ARCHITECTURAL DESIGN REPORT - ADDENDUM 01

The New Primary School in Mulgoa Rise

APPLICATION NO. SSD-11070211

DIAGRAM 1 - Overall Ground Floor Covered Structure Diagram – Superseded Design (NTS)

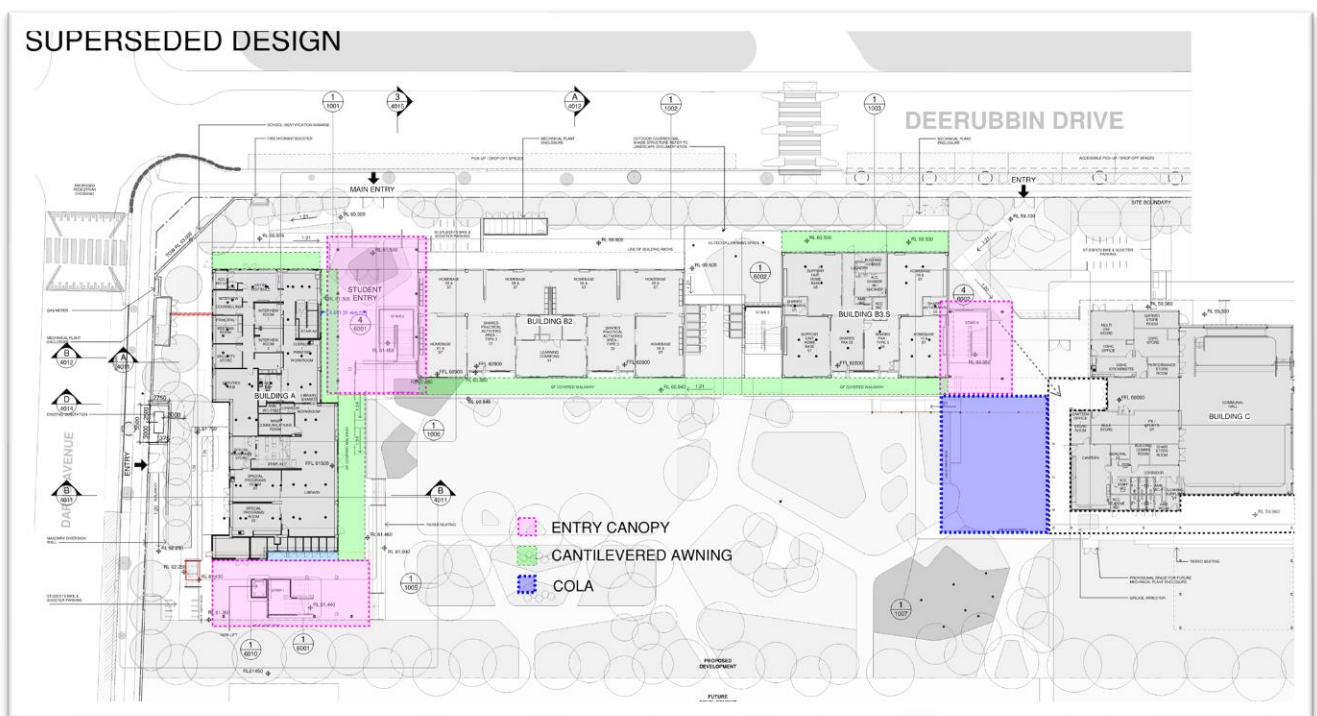
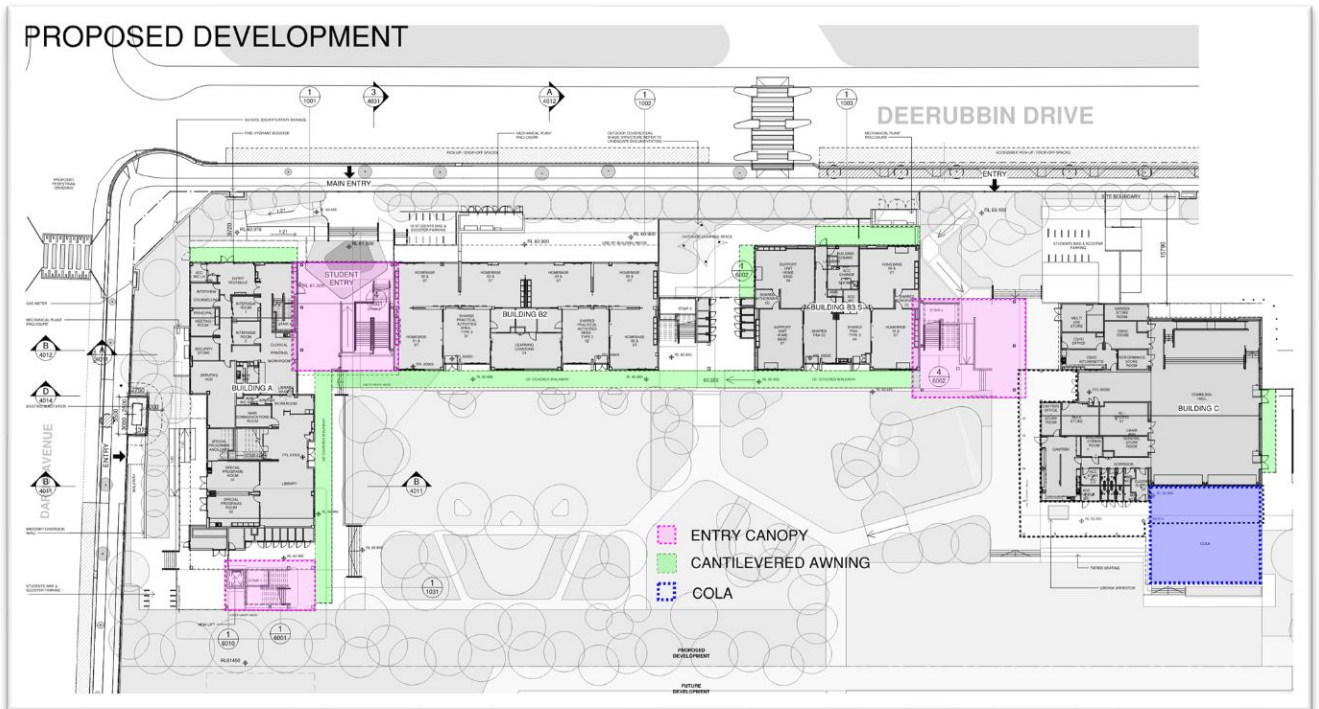
The area highlighted on the following drawing illustrates the extent of additions and reductions of roof area. This design rationalisation provides structural design efficiency for a more economical solution while still maintaining the canopies as an identifying design feature at the pedestrian entries along Deerubbin Dr and Darug Ave. Skylights have been removed due to complexity of maintenance. Awning placements have been rationalised to prevent overlapping with high-level canopies. The lower canopy to the west of Block C hall has been relocated to the southern side of Block C and is now identified as the COLA. Also refer to section 3.2.

3.2 Relocation of the COLA and adjustments to Block C Hall

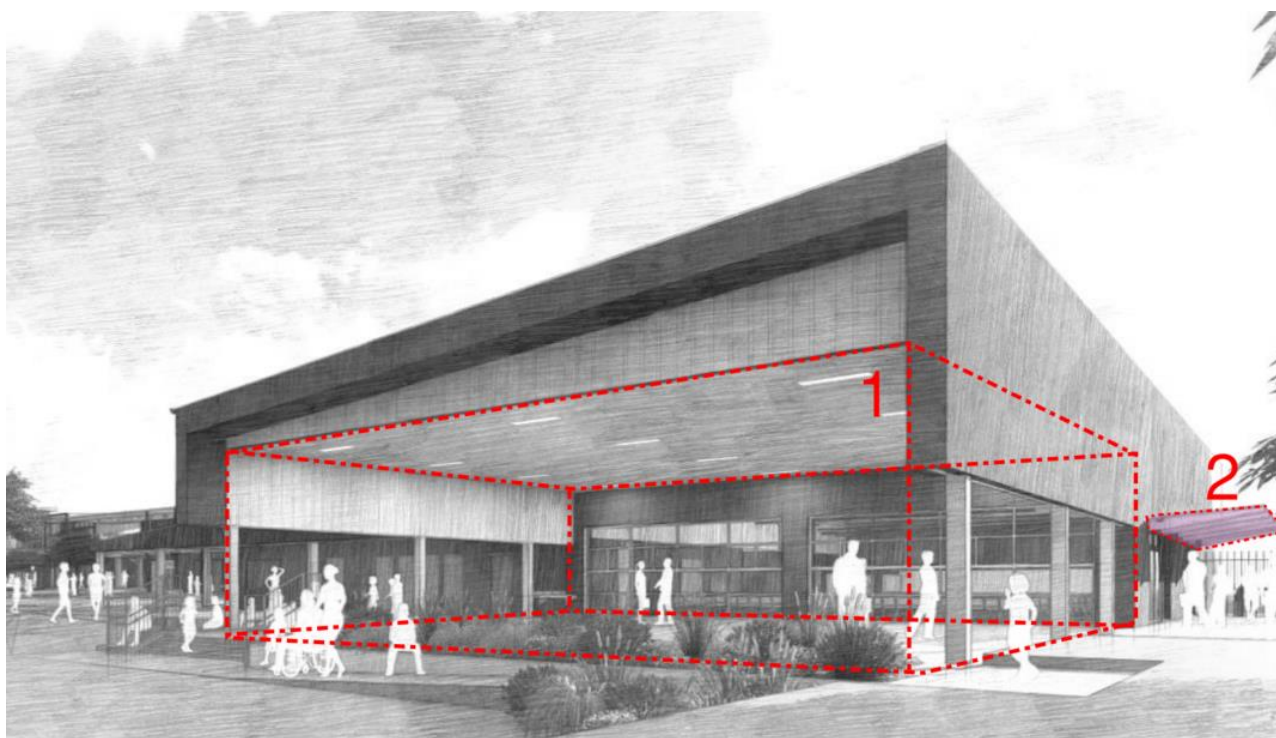
- (1) The COLA has been relocated to the southern end of Block C to better accommodate spill over from the hall during events and together with the tiered seating provide better connection to the future sports field.
- (2) The doors on the eastern façade have been downsized and relocated for egress purposes with a sheltering awning above. External cladding was adjusted to suit.
- (3) Block C roof has been rationalised and roof pitch is now proposed at 4° throughout for better drainage.

Building B3 – Diagram to depict changes to Building B3 (NTS)

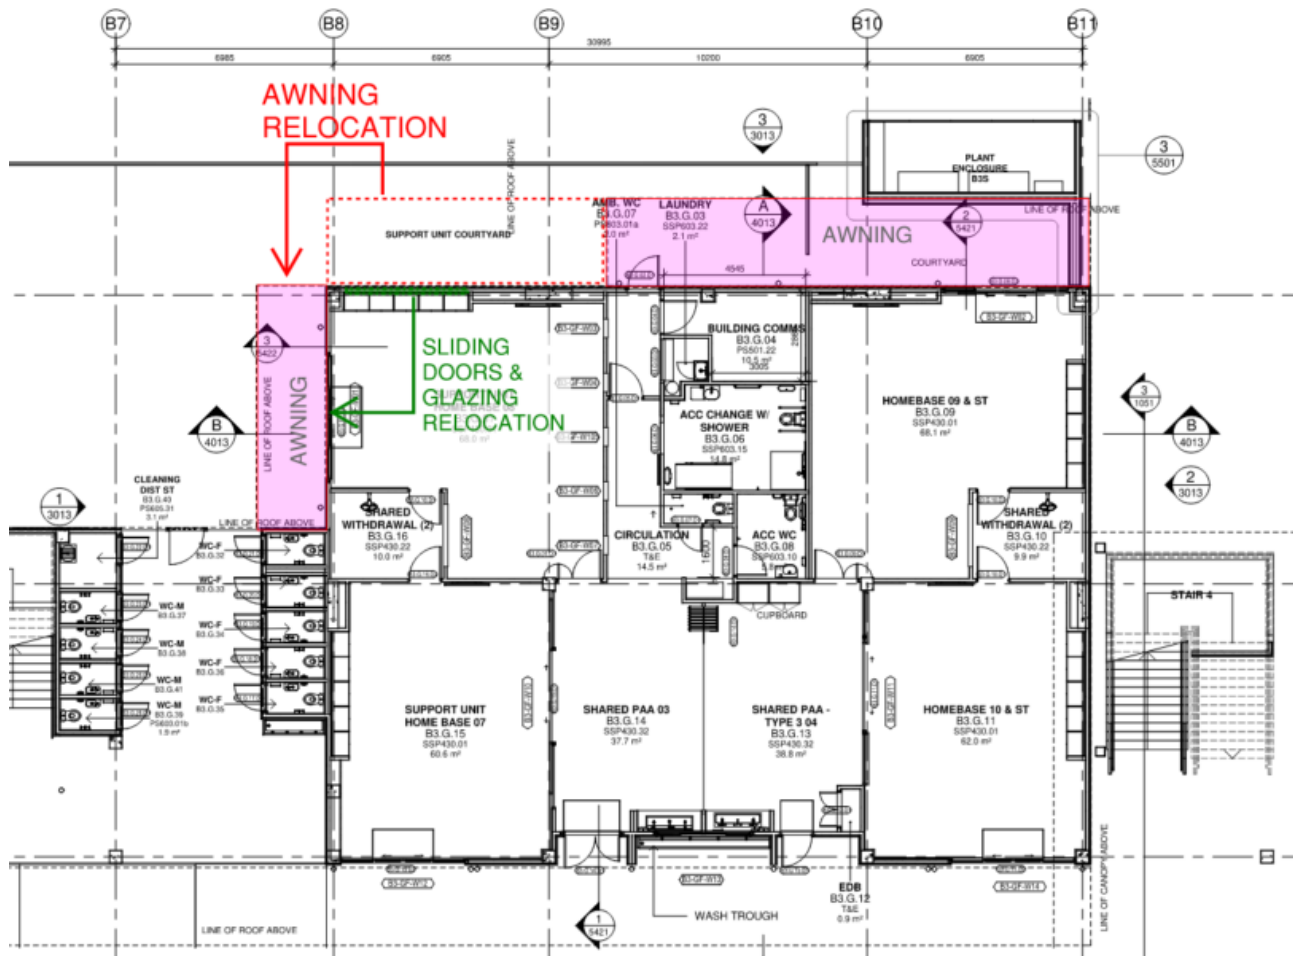
The following plan highlights a design change which has resulted in the minor adjustment to the North & West Elevation of Block B3S.

The glazed sliding door connecting the support unit to the outdoor learning area has been relocated from the northern façade to the western façade including associated awnings above.

The location of Stair 3 and student amenities between Block B2 and Block B3S have been swapped to achieve better circulation between Level 1 and the play area.

Proposed fencing section diagram (NTS)

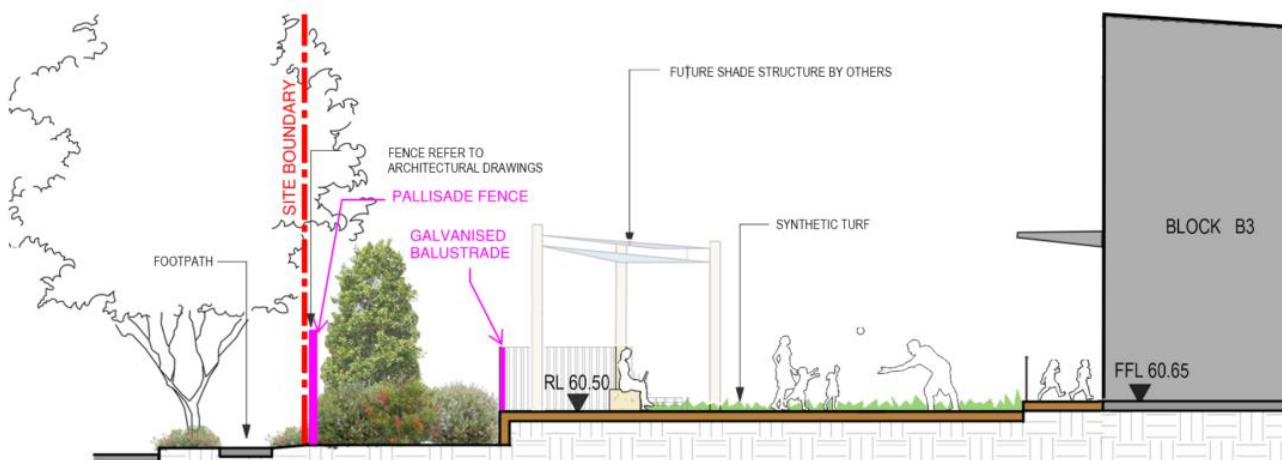
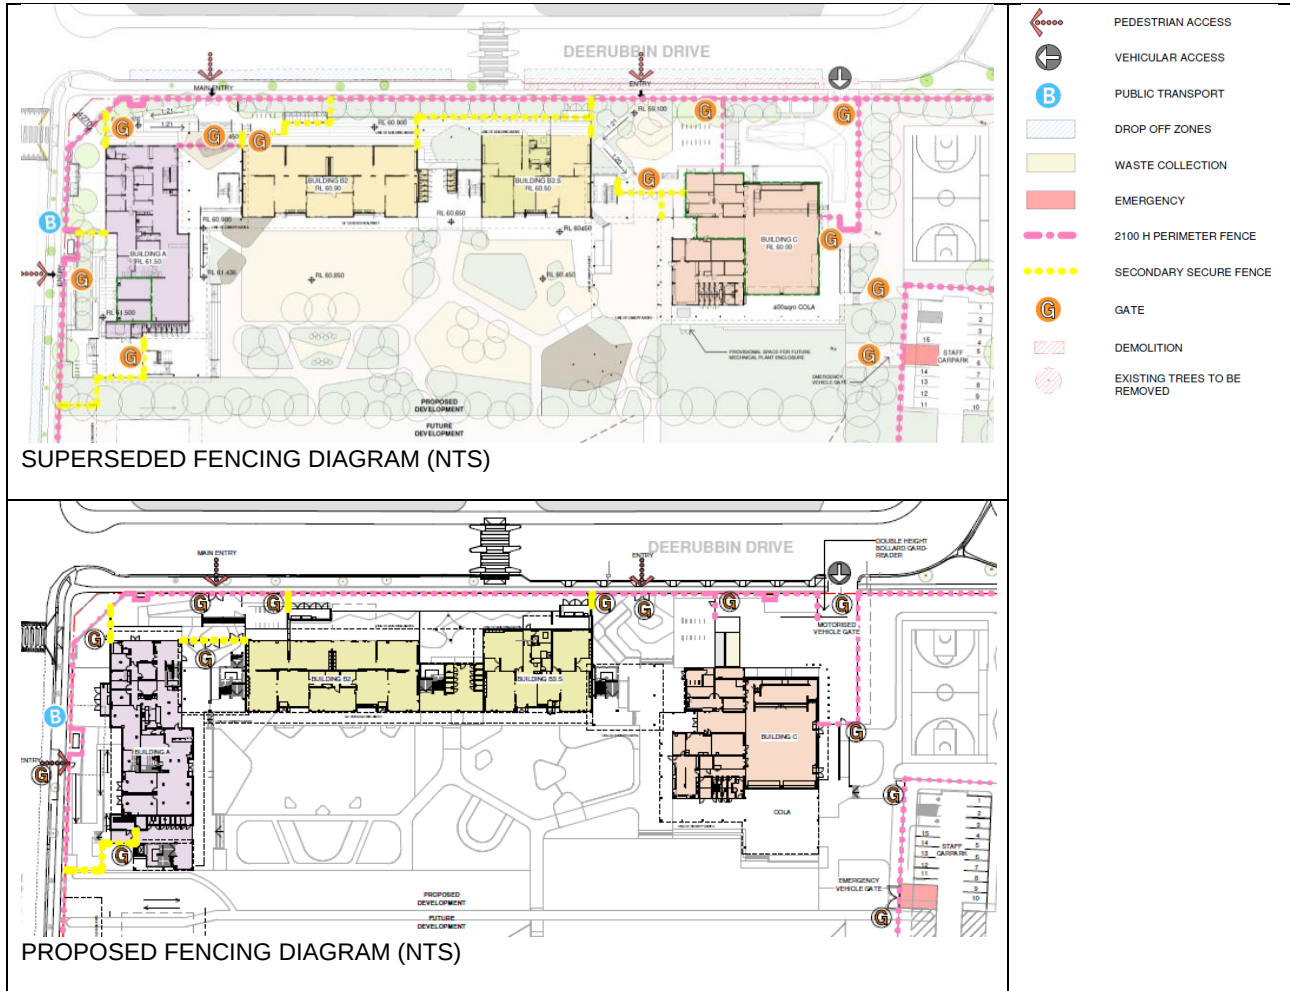
Further design development of the outdoor learning area between home base blocks B2 and B3S resulted with the elimination of much of the secondary security fence parallel to the boundary. Level changes in these areas will be managed via balustrades.

Proposed Part Ground Floor Entry Plan (NTS)

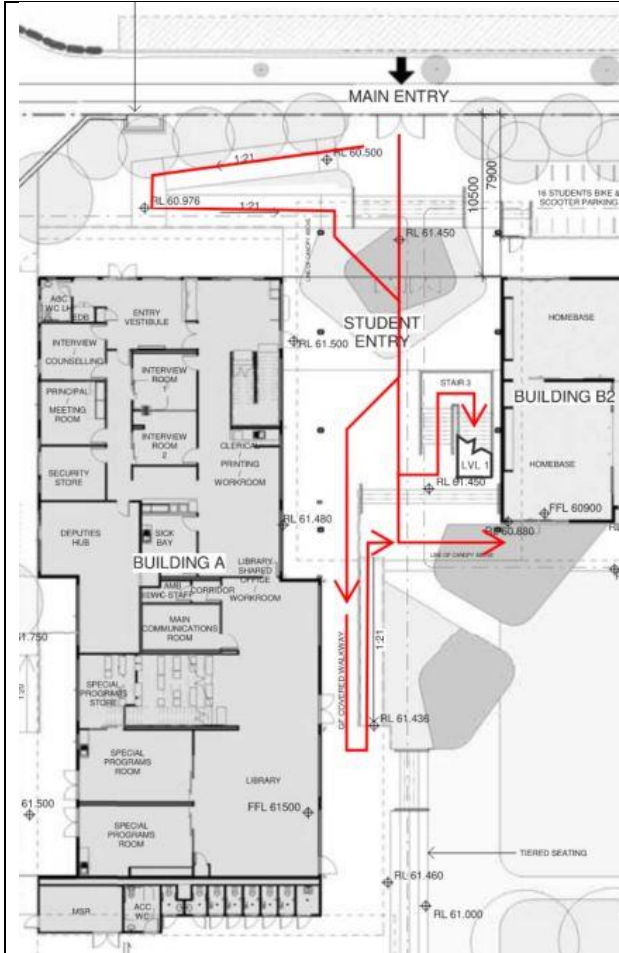
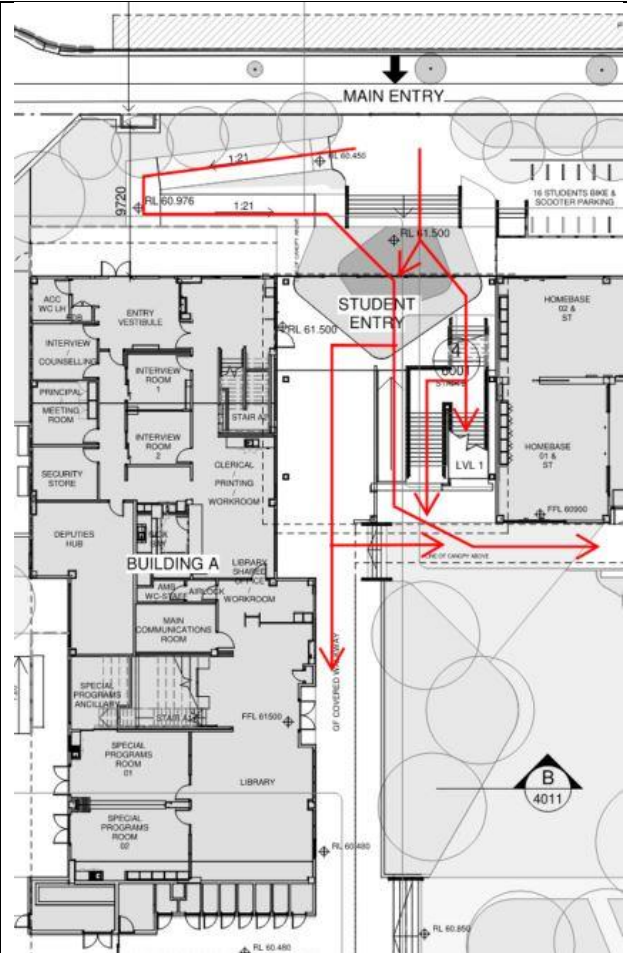
Layout of the main entry has been redesigned to better comply with egress paths and minimise travel distances; improve the circulation and student flow at peak times; ensure a covered path is always maintained.

3.6 Replacement of external vertical fins with sun shading hoods

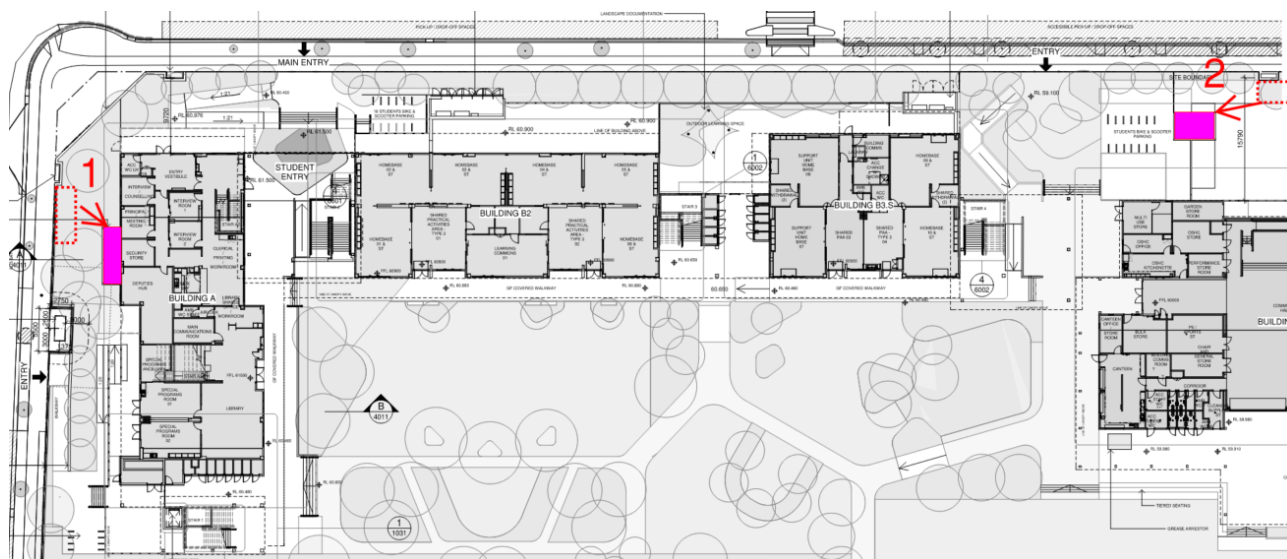
The decorative vertical-fins-screen on the northern facades of Block B2 and B3S and on the western façade of Block A have been replaced with 600mm deep coloured sun hoods for better solar protection from noon to mid-afternoon when solar heat gain is at a maximum. Fresh air louvres which used to be behind the screen have been rationalised to follow window pattern on the façade.
